COWLES & THOMPSON

December 22, 2004

**RE: Addison Arts & Events District
Festival Way Reconstruction**

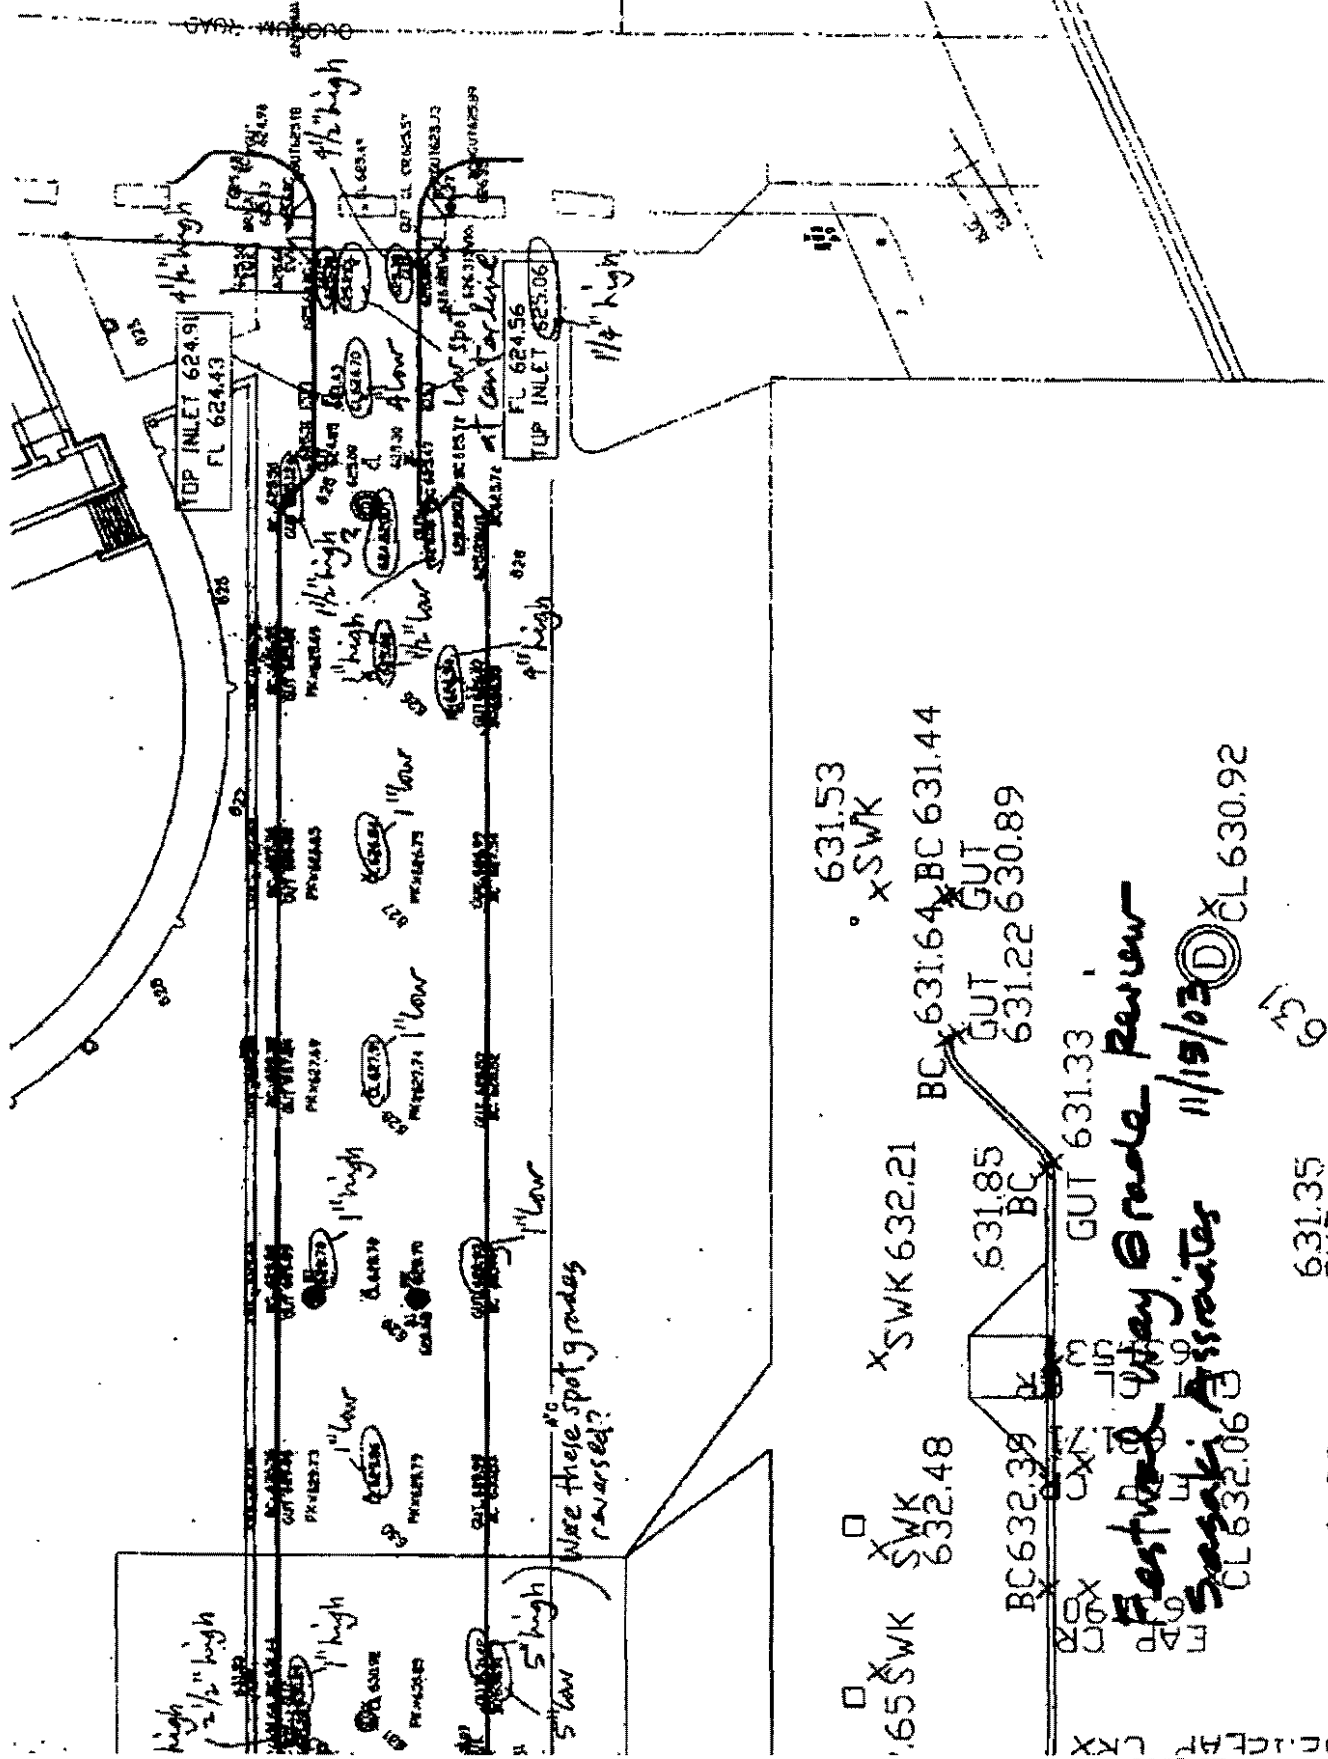
It looks like there still are discrepancies with design grades at the east end, of the Quorum Drive intersection. Two gutter grades are 4 1/2" too high, with a grade at the centerline that is lower. However, since the centerline grade just to the west is 4" lower than designed, it seems that water does flow from the intersection in a westerly direction and then into the curb inlets. If no one has observed problems with drainage in this area, maybe this is acceptable. I've marked a spot grade at a drain manhole with a question mark. Elevation 624.82 is labeled as "Gut", but if it is really the manhole elevation, it is too low.

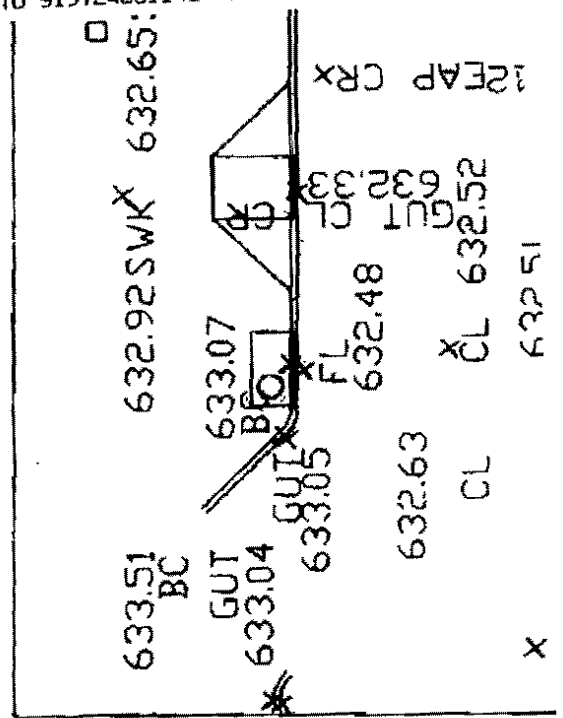
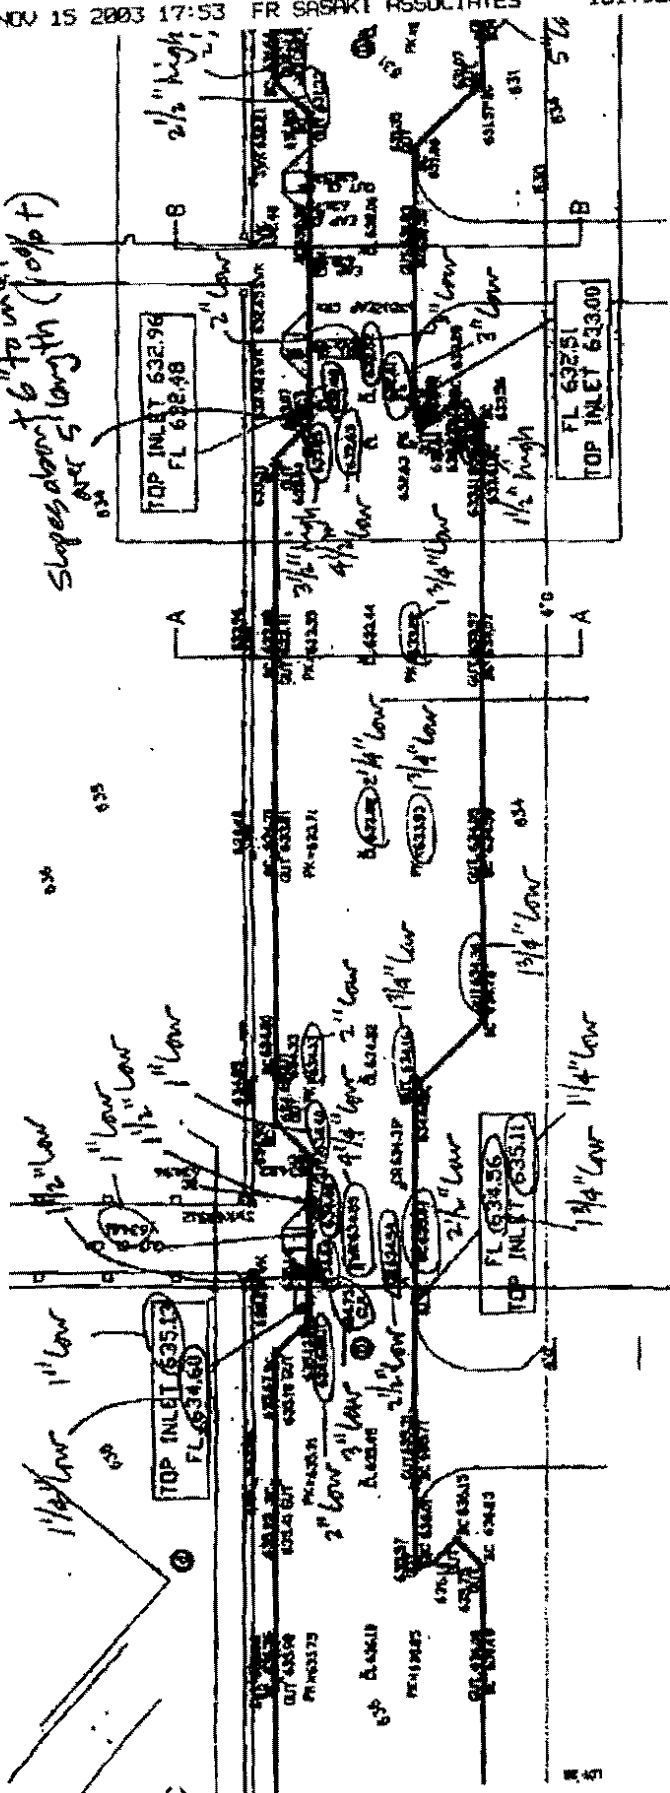
It looks like there still are discrepancies with design grades at the east end, at the Quorum Drive intersection. Two gutter grades are 4 1/2" too high, with a grade at the centerline that is lower. However, since the centerline grade just to the west is 4" lower than designed, it seems that water does flow from the intersection in a westerly direction and then into the curb inlets. If no one has observed problems with drainage in this area, maybe this is acceptable. I've marked a spot grade at a drain manhole with a question mark. Elevation 624.82 is labeled as "Gut", but if it is really the manhole elevation, it is too low.

Festival Way @ road - paving
Sasaki Associates 11/15/03

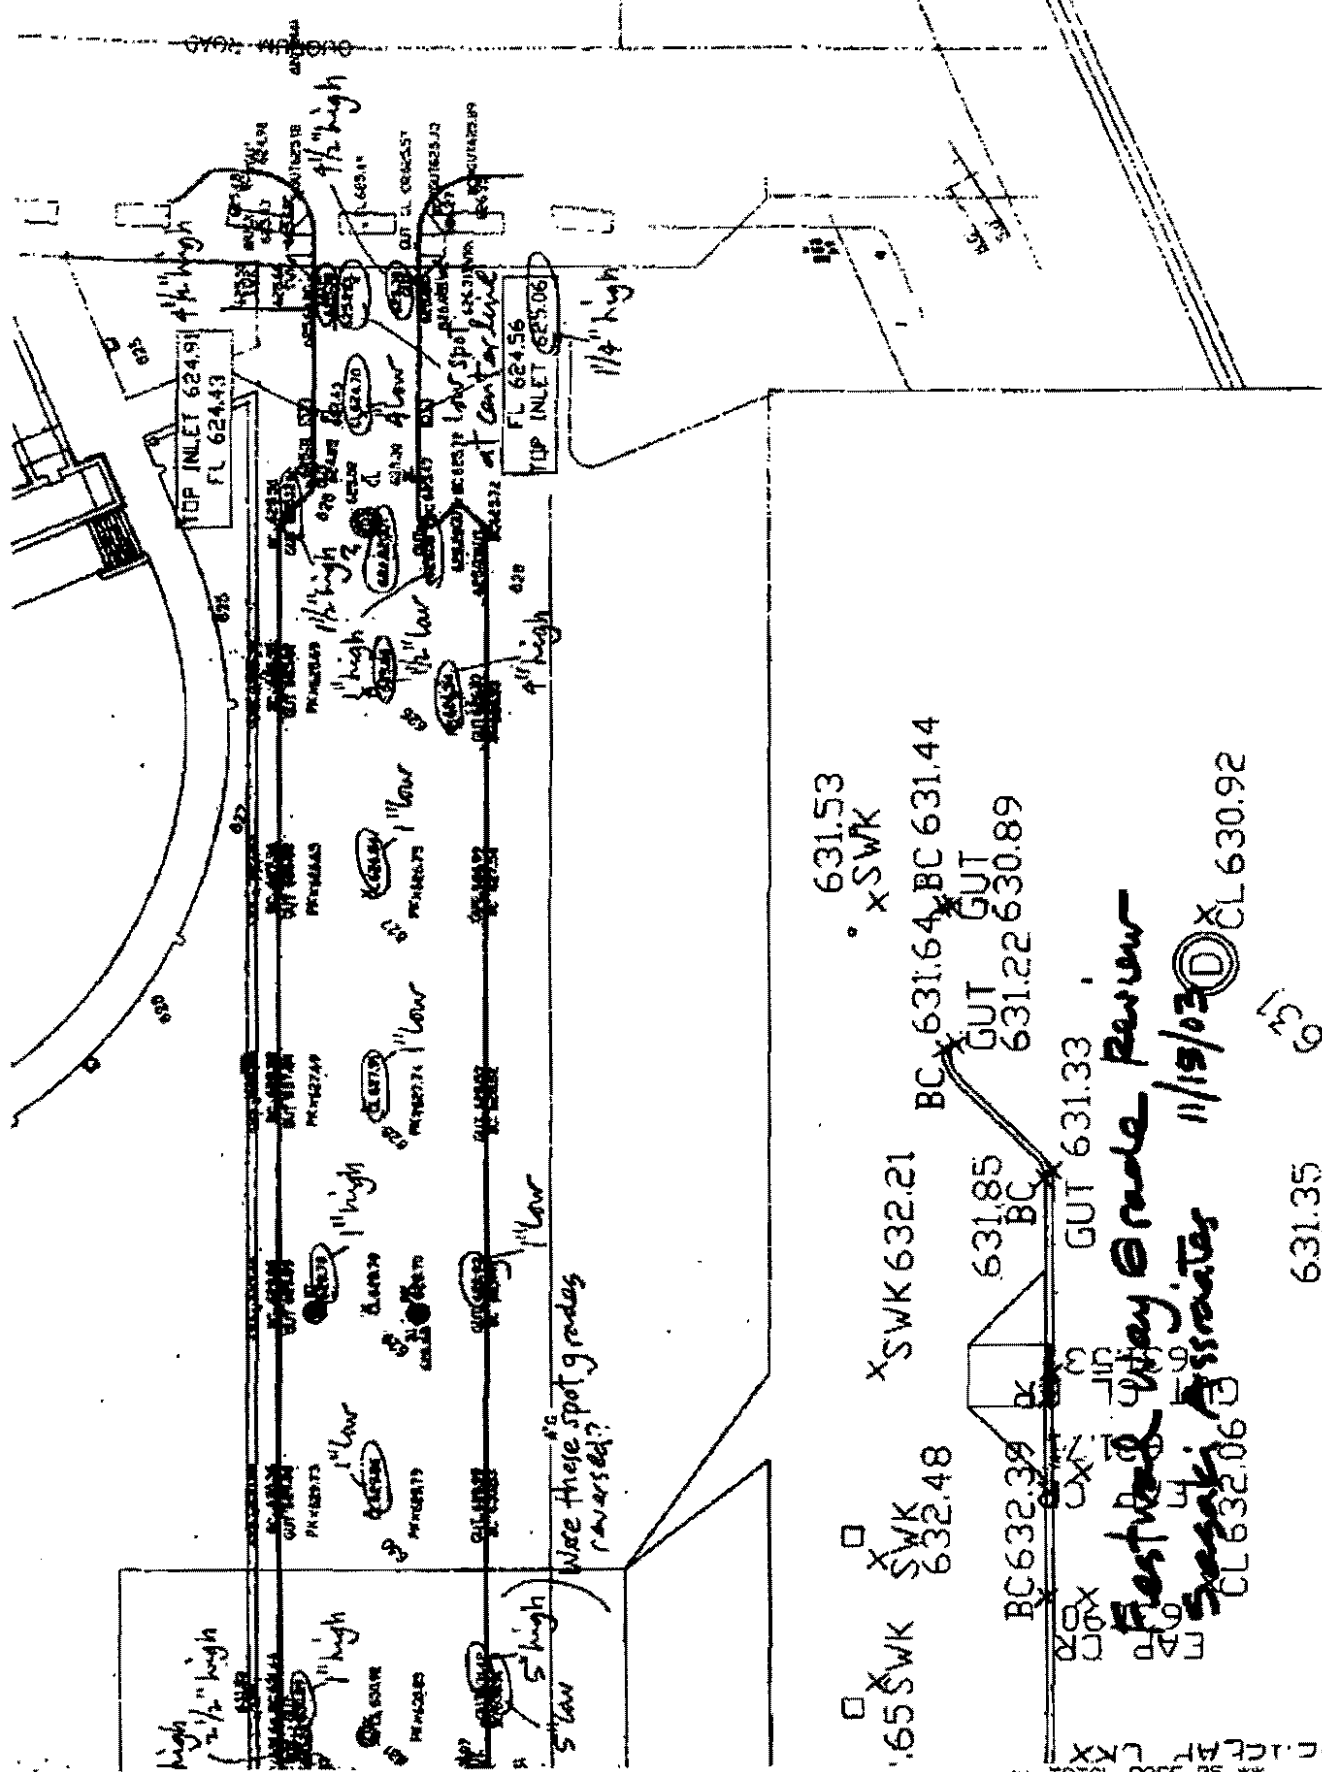
Slopes down 6" to inlet
over 5' length (0.012)

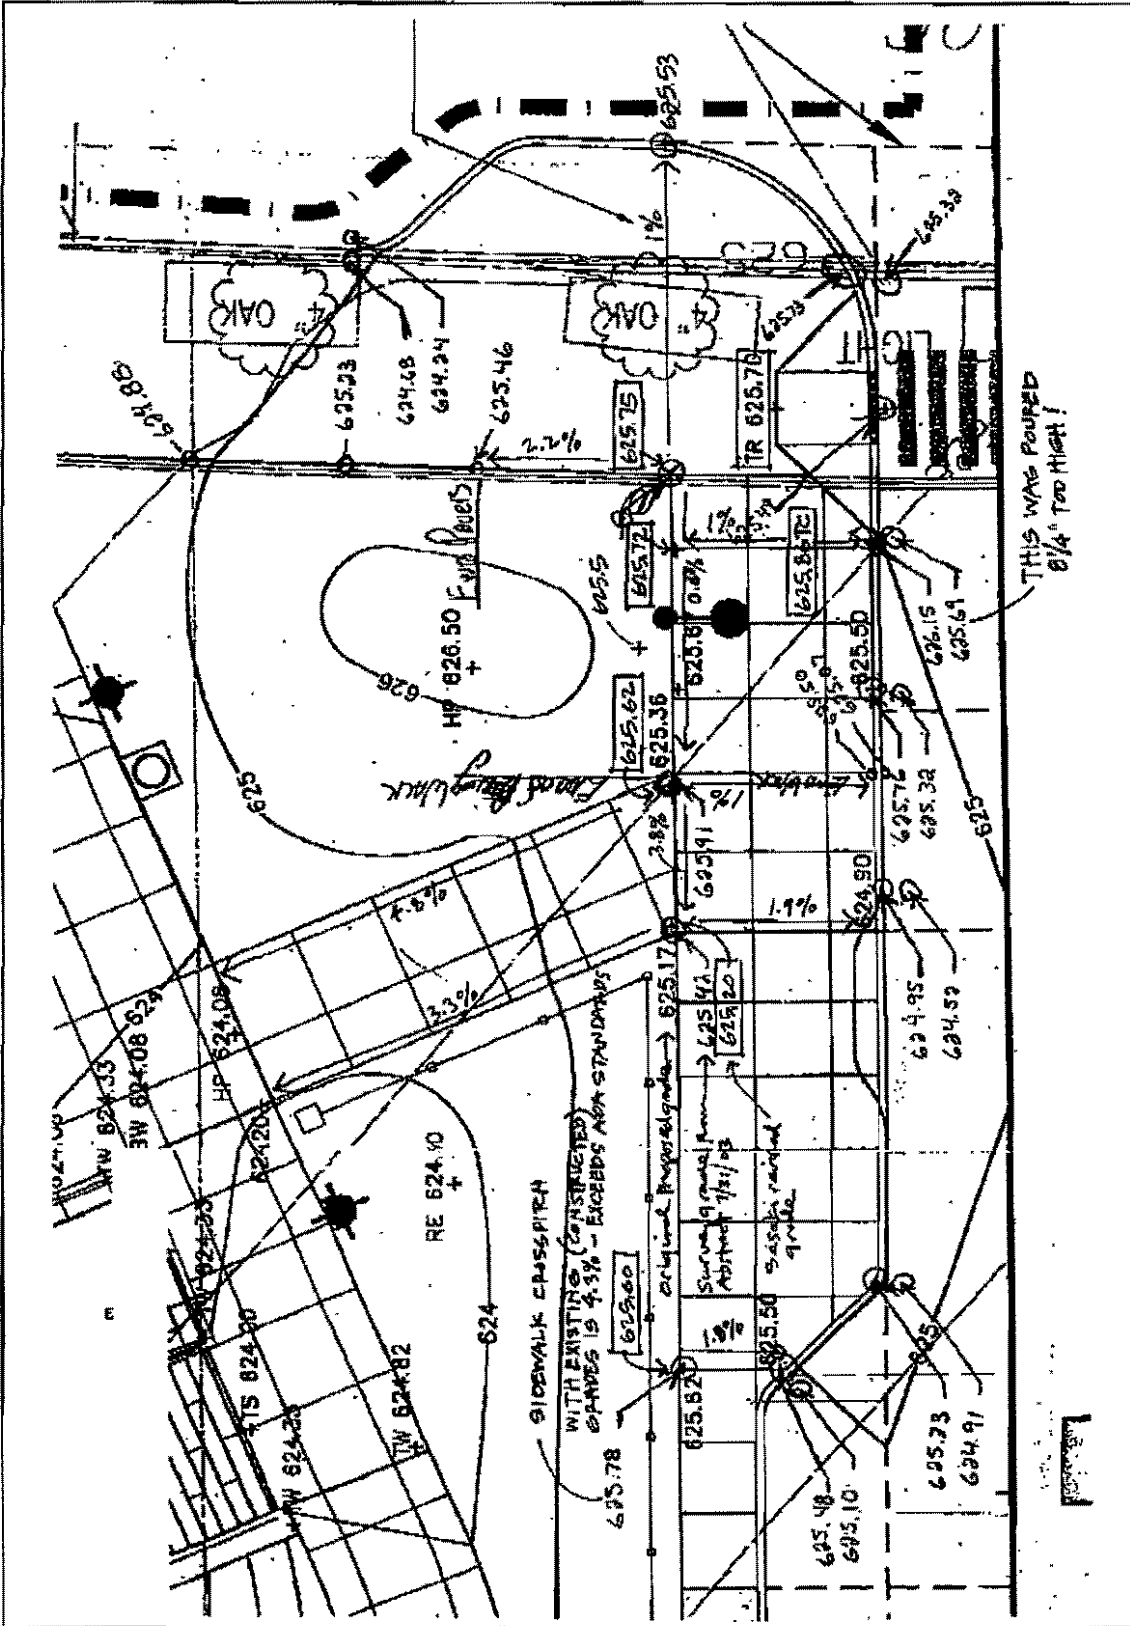
I'm attaching our markup of grade information for the SE corner of the site we received today from Abstract, which is being issued as SK-35. Our proposed grades are indicated with a box around them, as noted on the sketch.

I've revised the grading trying to avoid reconstructing the curb and pavement in Festival Way. However, in the area of the HC ramp (at BC el. 625.69), the roadway pavement has been poured more than 8" too high. An alternative to removing the road pavement is to reconstruct a section of curb from the end of the westerly wing on the ramp to TC spot elevation 625.76. I'm suggesting a 2" high minimum curb at the end of the ramp wing to avoid a crosspitch exceeding ADA standards from the curb to the plant bed to the north. The drainage in this area will go in the opposite direction from what was intended, but it's only for a limited area. The grades along the back edge of the sidewalk have been revised so that crosspitches on the sidewalk will be less than 2% as required by ADA. As constructed, they are now in the 3 to 4% range. Also, the slope on the walk connecting the Festival Way sidewalk and the Upper Channel area must be less than 5%, so I've made revisions to grades accordingly.

The last grade that was shot on the west side of the back edge of sidewalk is el. 625.78. As noted on the sketch, the sidewalk crosspitch here is about 4.3%. It should be lowered to around 625.6 to comply with ADA. I don't know how much further to the west the sidewalk would have to be removed before the crosspitch becomes less than 2%.
